THIRD FLOOR PLAN  
 61 INDIA STREET  
 BY: JOSEPH REYNOLDS 2/06  
 SHOWING NEW BATH &  
 KITCHEN/ENTRY HALL WALL

THIRD FLOOR PLAN  
61 INDIA STREET  
SHOWING NEW BATH & KITCHEN/ENTRY HALL WALL

BY: SEAN REYNOLDS 2/06; REVISED 3/8/06 (per meeting with Captain Cass)  
Scale: 1/4" = 1 foot

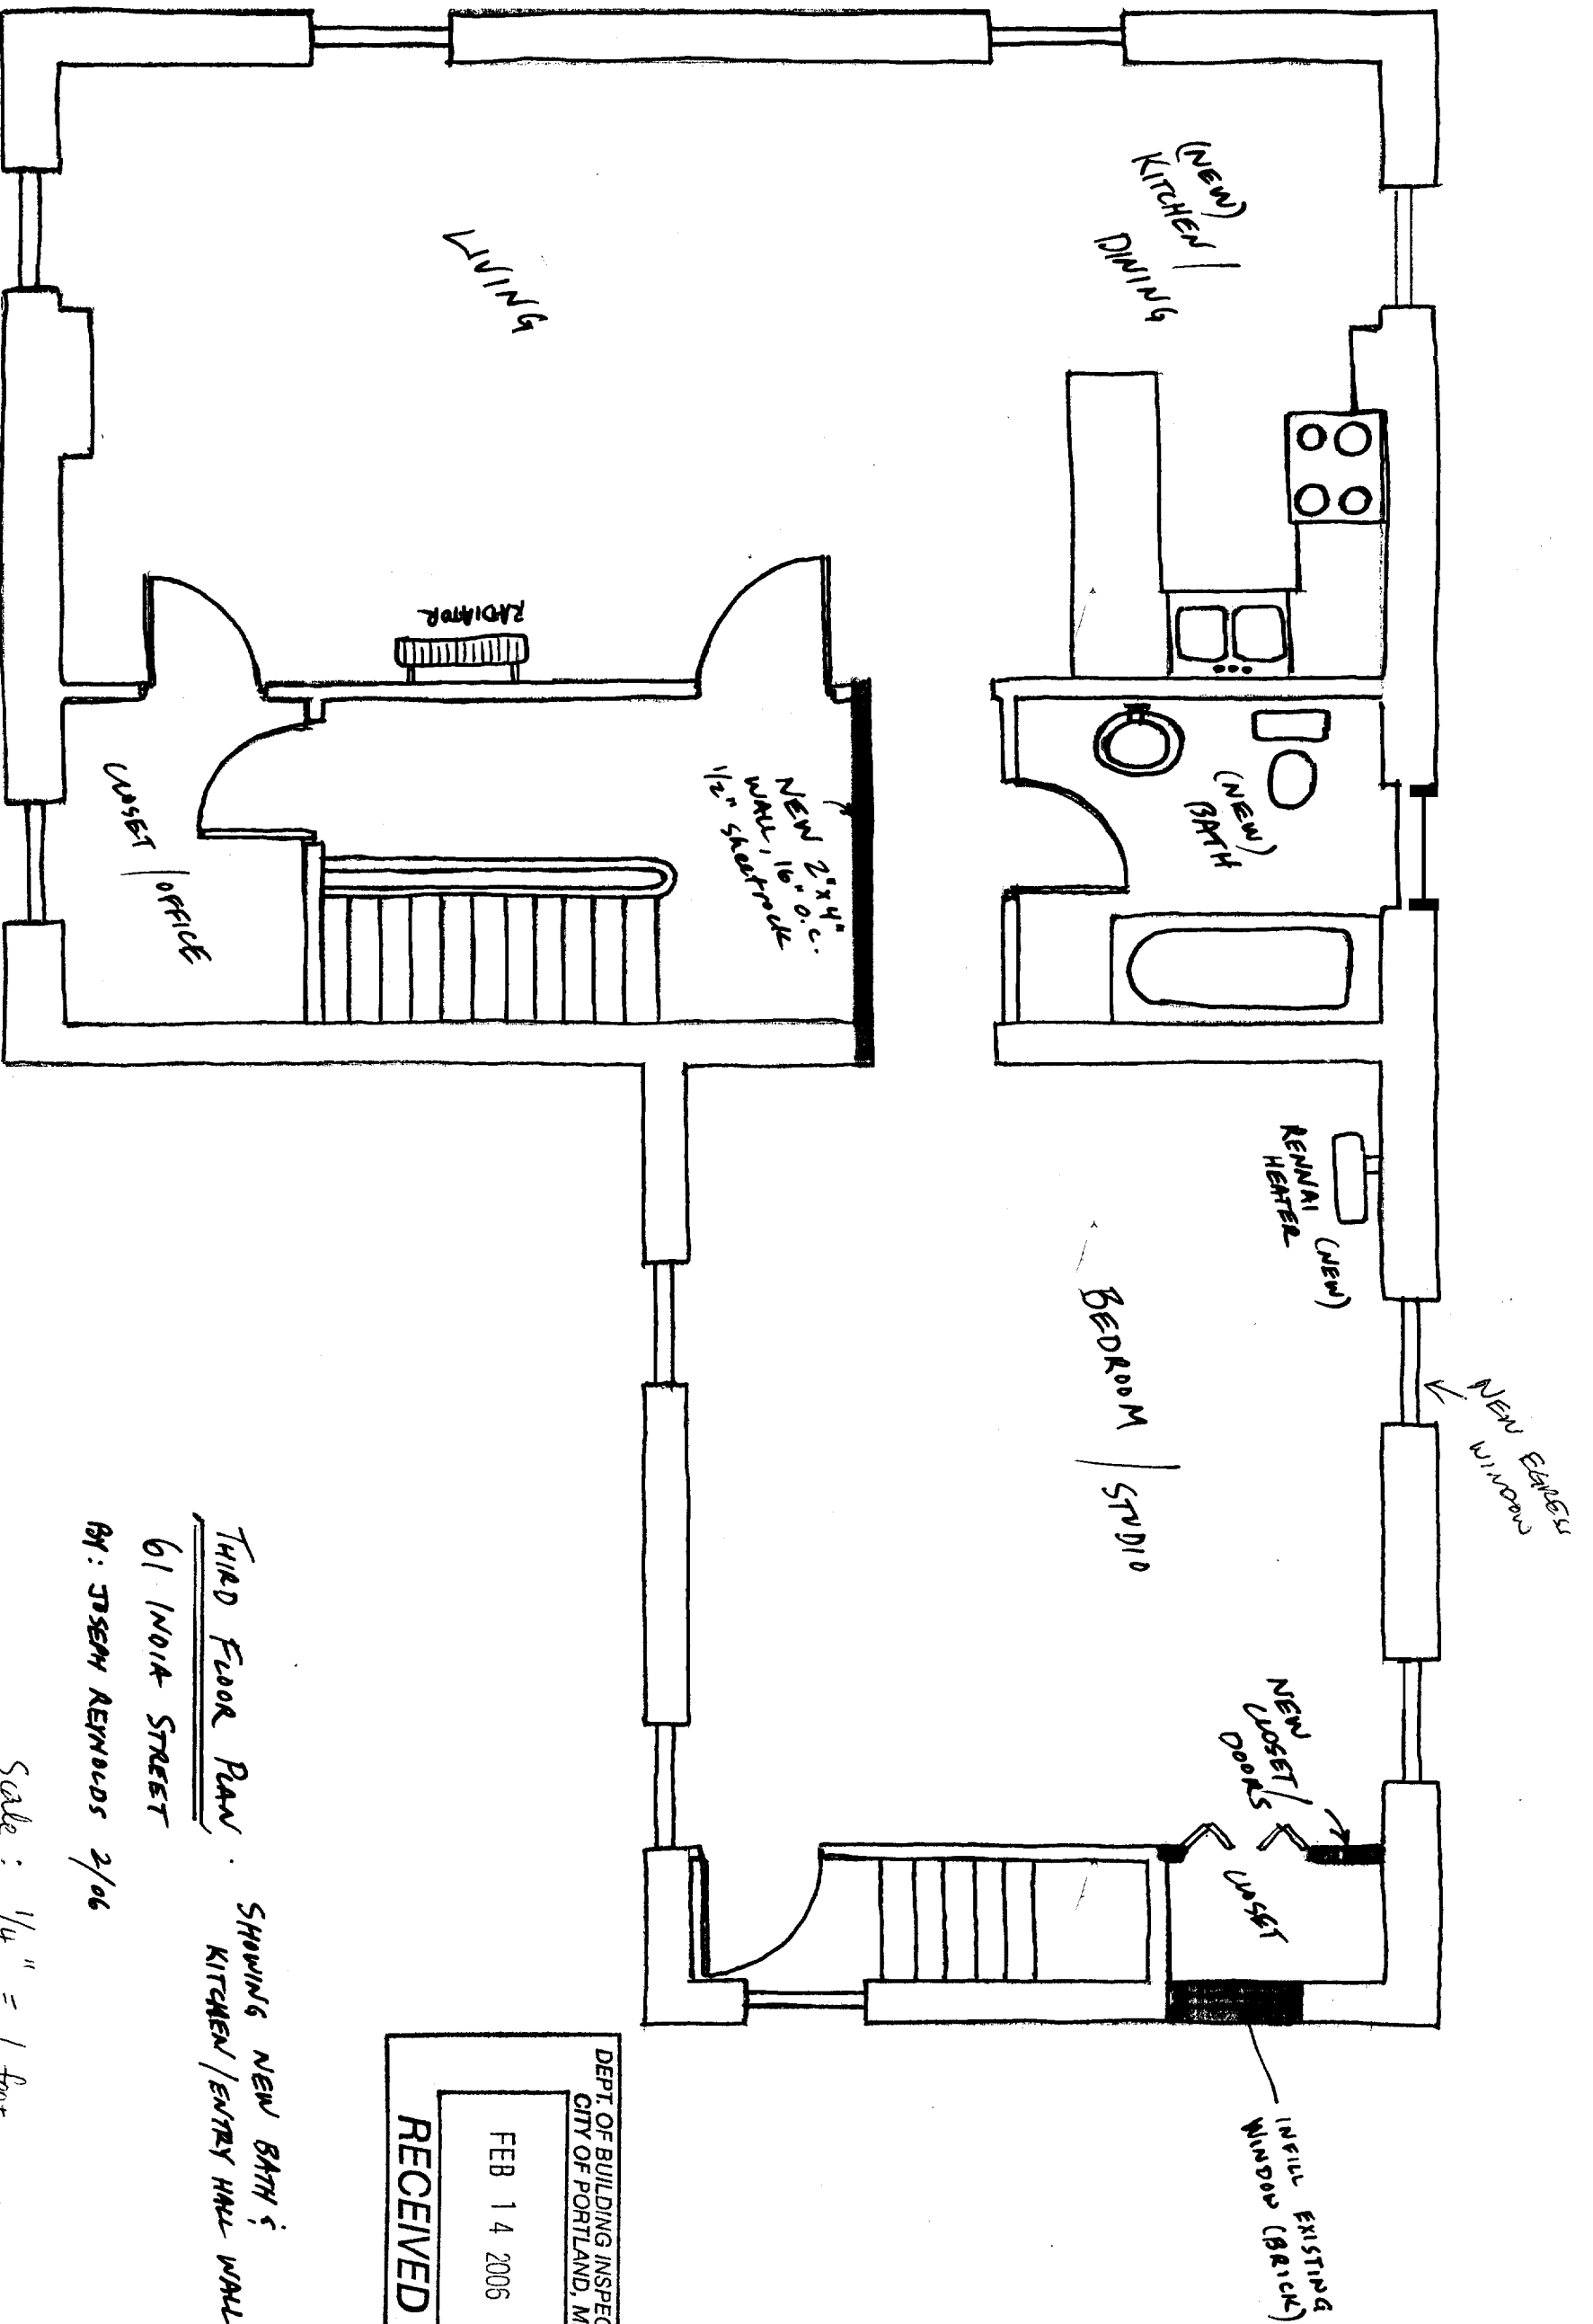
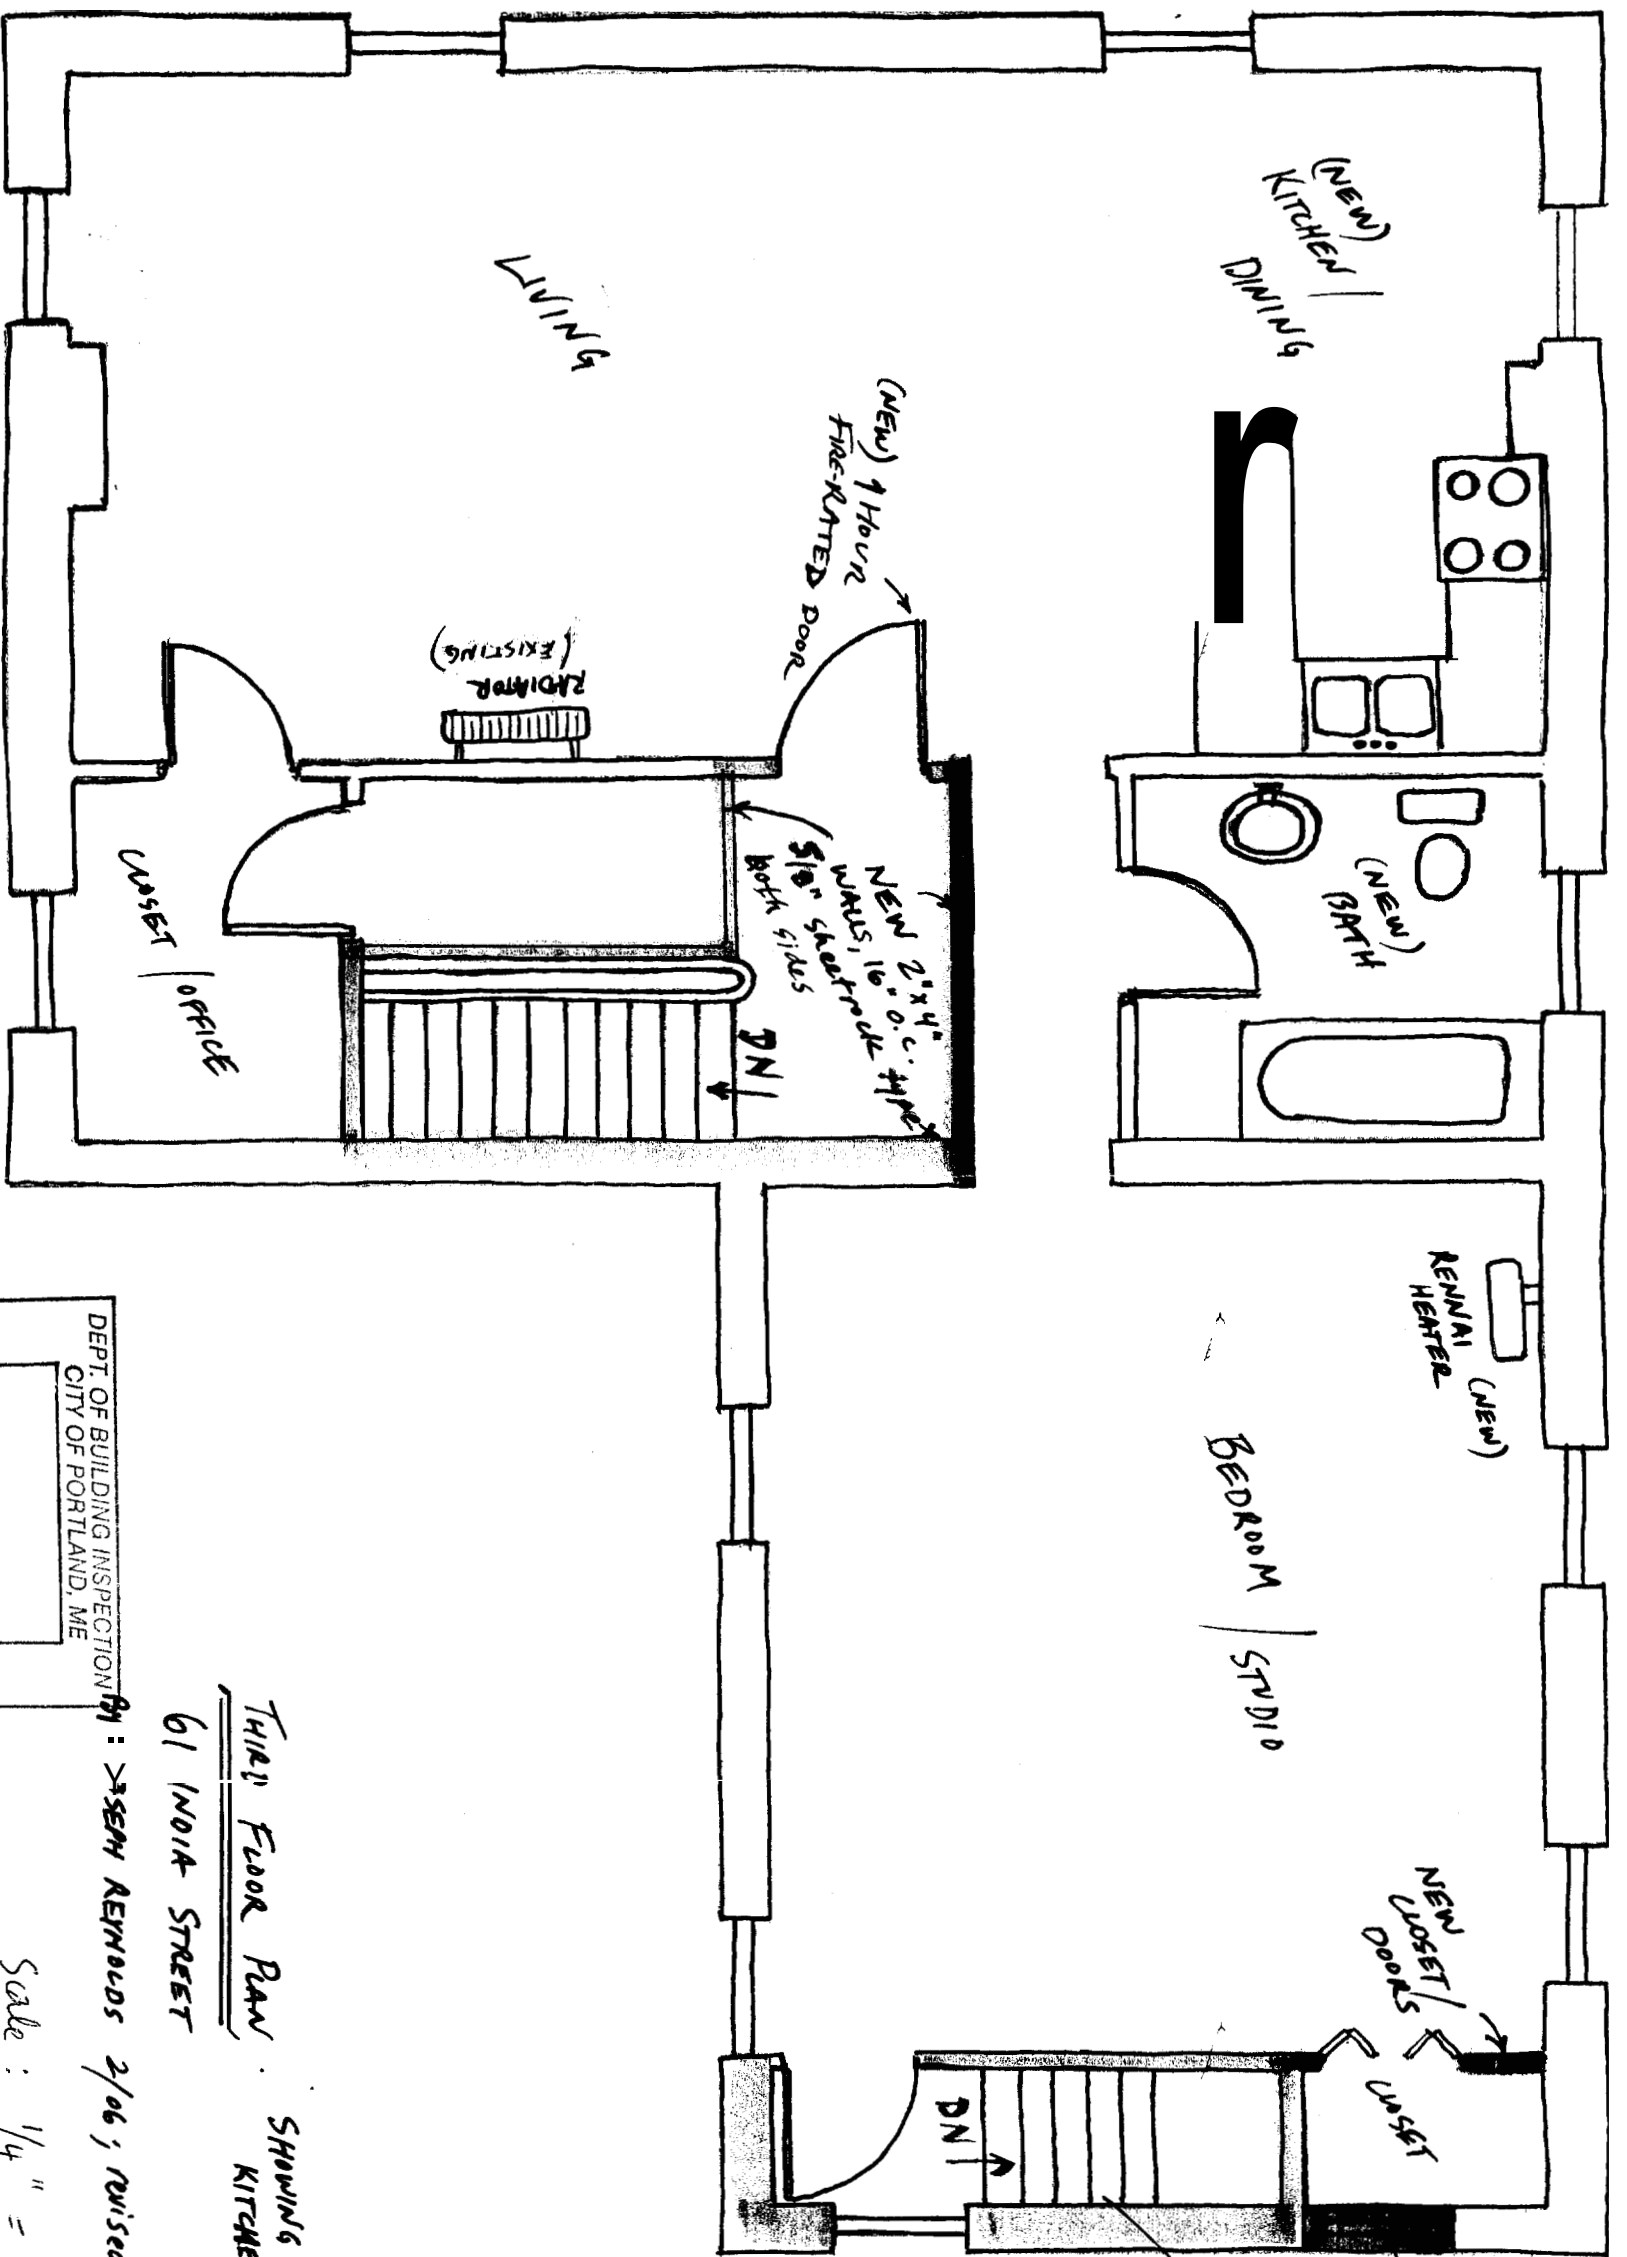
NOTE: STAIRWAY TO BE 1 HR. FIRE-RATED ALL THE WAY TO FIRST FLOOR (EXIT); SECOND FLOOR ACCESS TO BE REMOVED AND REPLACED WITH EGRESS WINDOW IN SAME ROOM (KITCHEN), S. AS ON MAINTAIN TWO MEANS OF EGRESS FOR SECOND FLOOR RESIDENCE.
